London Hydro Inc. Responses to OEB Staff Follow-up Questions EB-2023-0037 February 9, 2024

Staff Follow-up Question – 1

Ref: LH_Attachment_E_2024-IRM-Rate-Generator-Model_Updated_20240109_20240124.xls

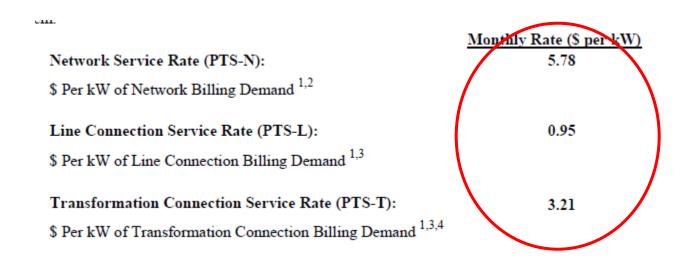
The decision led to an increase of \$0.02 per kW for the Network Service Rate.

OEB staff has updated the LDC's rate generator with the final UTRs as follows:

1) Please confirm the accuracy of the Rate Generator update in the reference.

1) London Hydro confirms that the Rate Generator Model reflects the 2024 Final Uniform Transmission Rates (UTRs) effective January 1, 2024, as noted above.
